RE-ESTIMATION OF ELEVATIONS WITHIN THE COHASSETT FLOW
AT THE REFERENCE REPOSITORY LOCATION

Prepared for
The United States Nuclear Regulatory Commission
Washington, D. C.

At the request of the U. S. Nuclear Regulatory Commission and under a subcontract to Engineers International, Inc. of Westmont, IL, a document review of a report by Harold D. Taylor of D.A.S.A. entitled "Geostatistical Estimation of Elevations Within the Cohasset Flow at the Reference Repository Location" was conducted.

Figure 8. Contour map of kriged elevation of the bottom of Cohasset flow-top (Contour interval = 20')

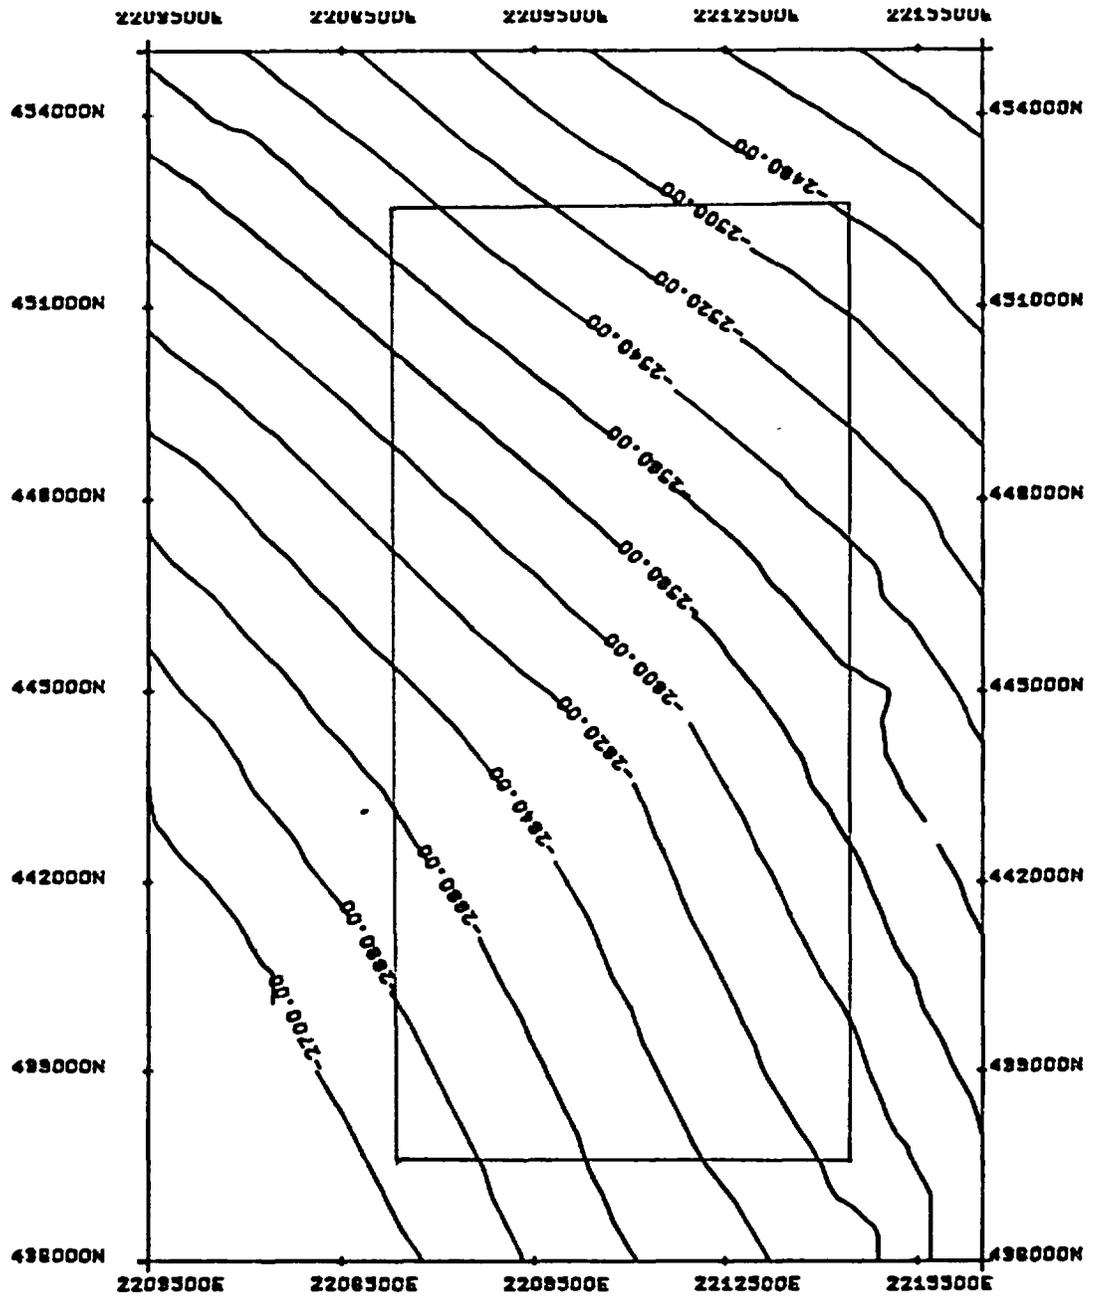
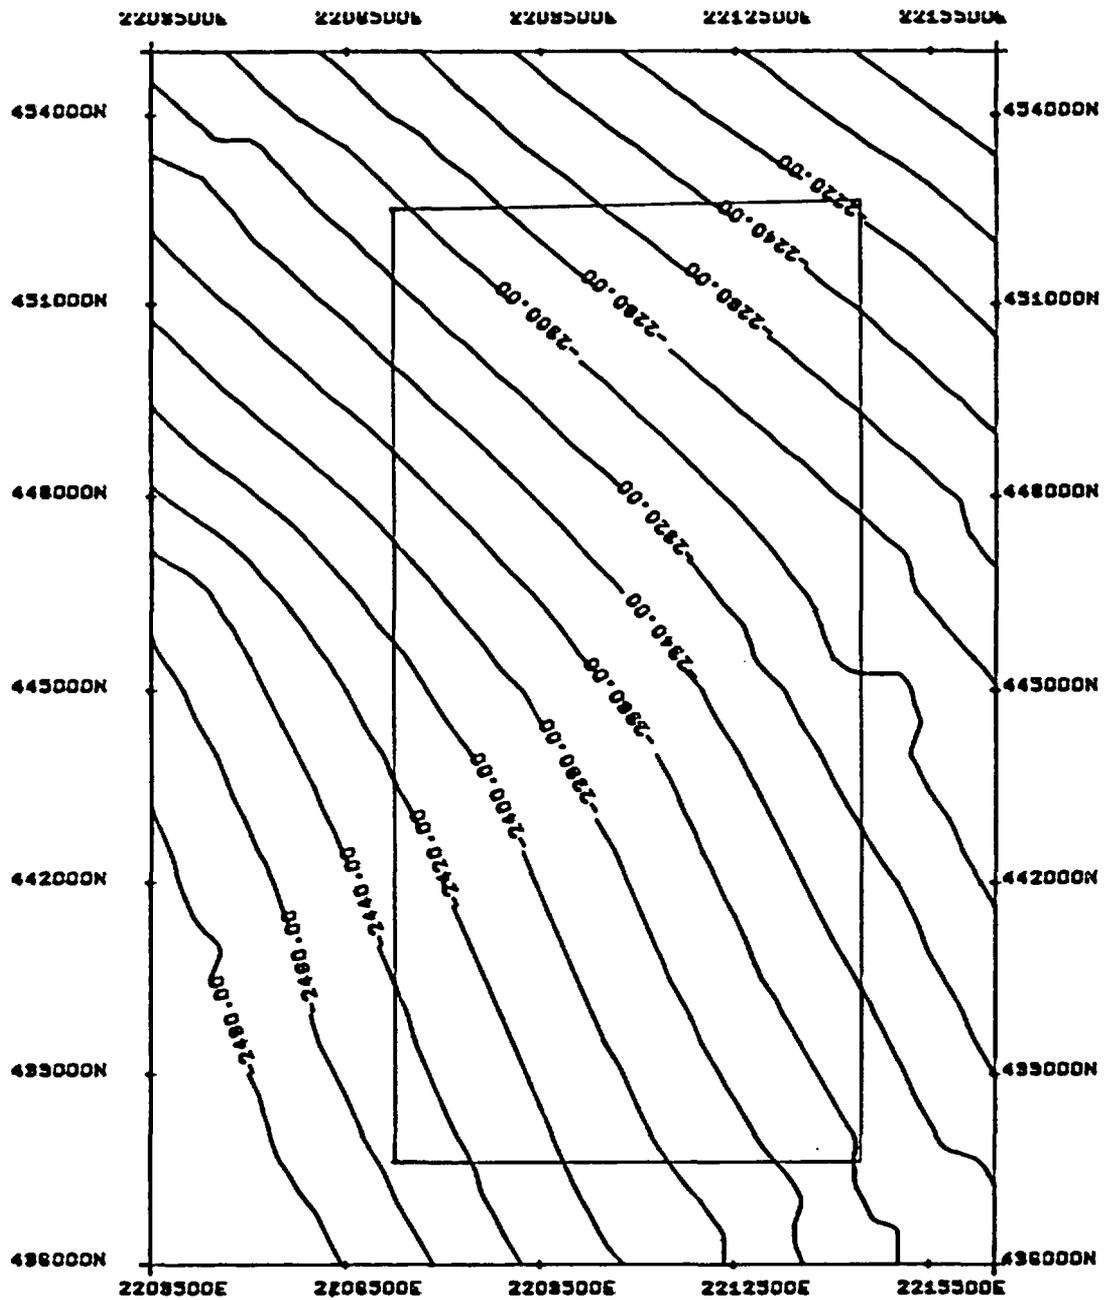
Figures 8 and 9 are contour maps of the kriged elevation for the bottom of flow-top and the top of flow-bottom. As such, Figures 8 and 9 correspond to Figures 12 and 13 of Taylor (pp.25-26). The obtained contours of Figures 8 and 9 are quite similar to Taylor's, except the southwest portion of the area. This difference is primarily caused by Taylor's adoption of multi-step estimation process and also by using the contour map of top of basalt produced by Rockwell Hanford Operations, rather than his own kriged map. (Please note that, this decision by Taylor further complicates the problem of quantifying the uncertainty of the estimates).

Figure 11. Contour map of kriging standard deviation
 Top of flow-bottom (Contour interval = 1')

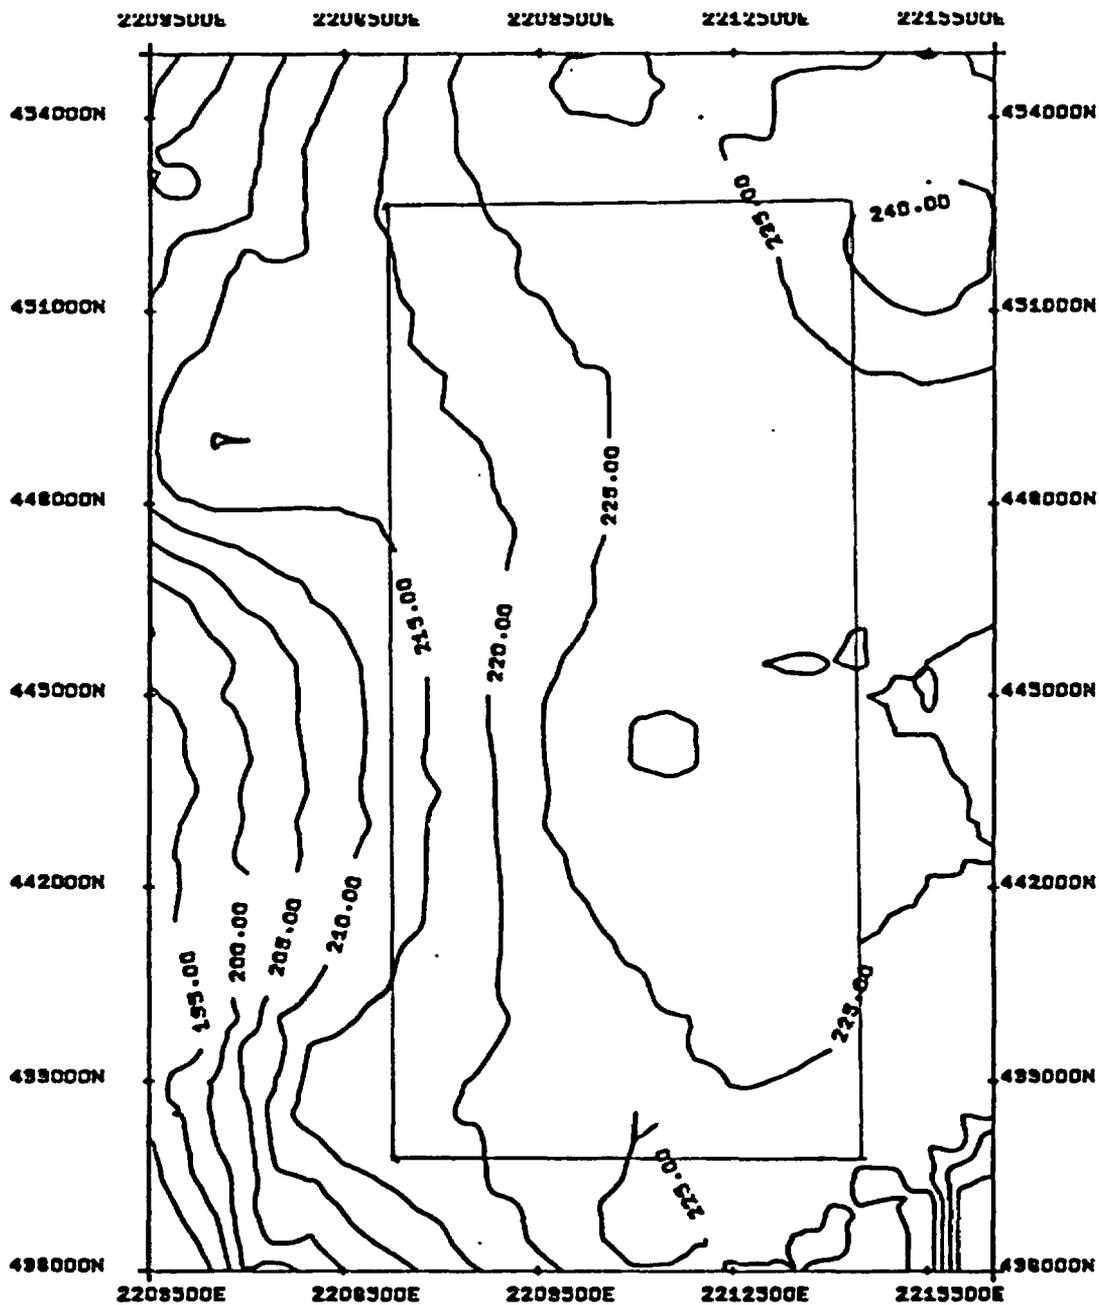
Figures 10 and 11 are contour maps of kriging standard deviation of the bottom of Cohasset flow-top and the top of flow-bottom. As such, these correspond to Figures 14 and 15 of Taylor's report (pp.27-28). Although the general shapes are similar between the two, there exists a large difference in values. This is particularly true between Fig. 11 of this report and Fig. 15 of Taylor's. The values given in this report are less than half of Taylor's. Again, this discrepancy is caused by his multi-step approach of estimation which carried along the uncertainties associated with estimating 3 different variables.

Figure 12. Minimum difference in elevations at one-sided 80% confidence interval (Contour interval = 5')

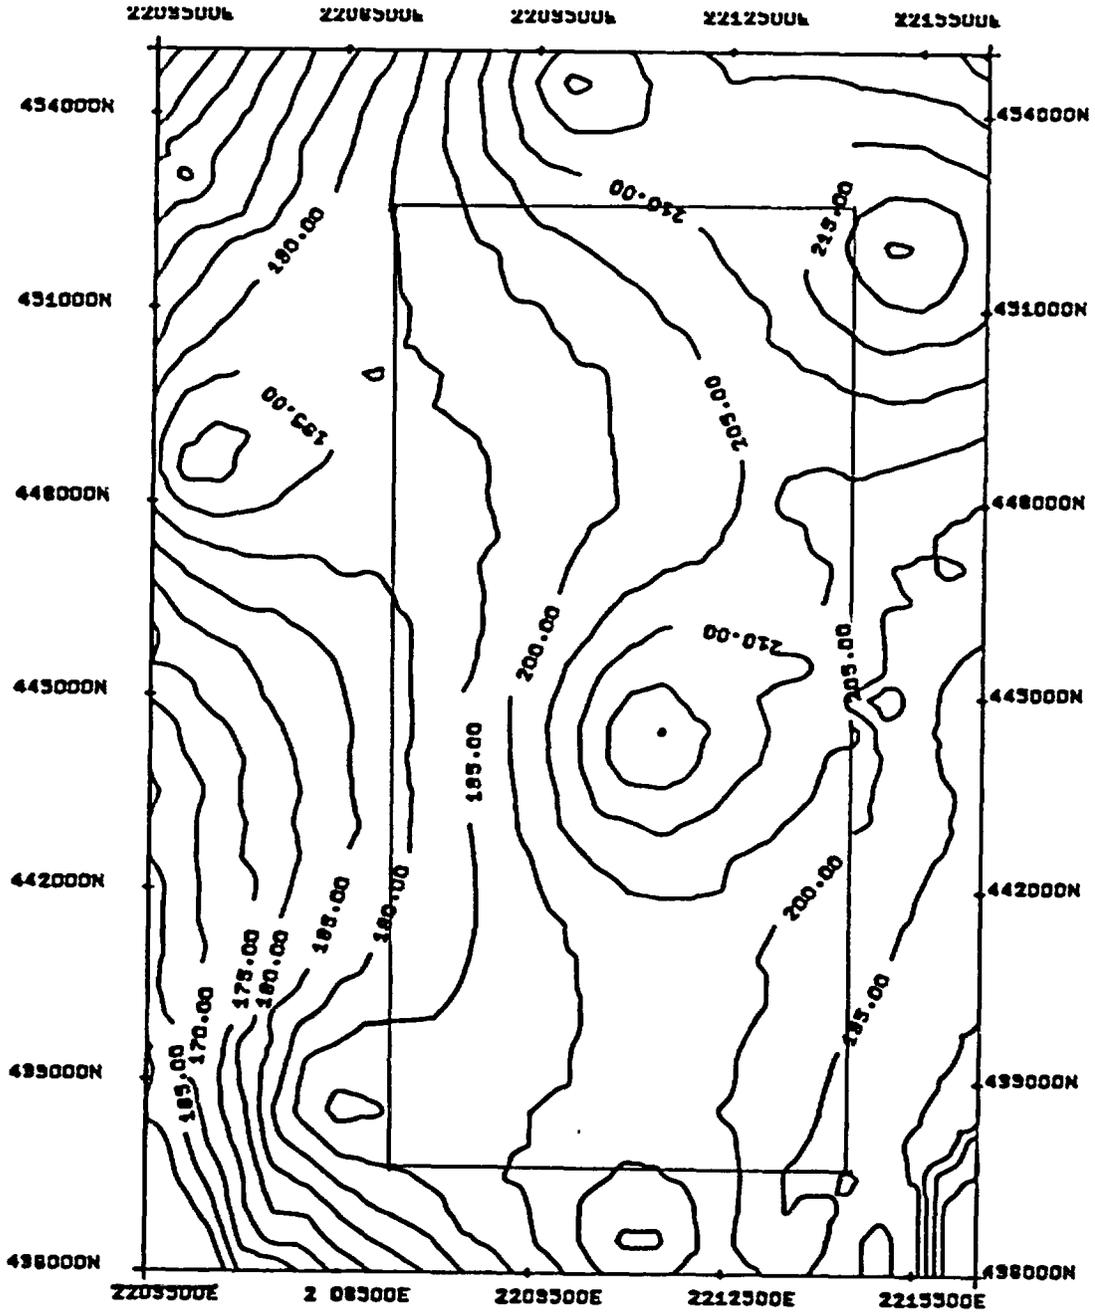
Figure 12 is the contour of the minimum differences at 80% confidence level (i.e., $Z = 0.84$) assuming normality of errors and using one-sided rather than two-sided interval. From this figure, a minimum thickness of approximately 212' is found along the western edge of the repository layout area, which is different than Taylor's results (See Figure 19 on p. 33). At 95% confidence, the minimum thickness is now reduced to approximately 188' which is still thick enough to satisfy buffer zone requirements of the repository design (See Figure 13).
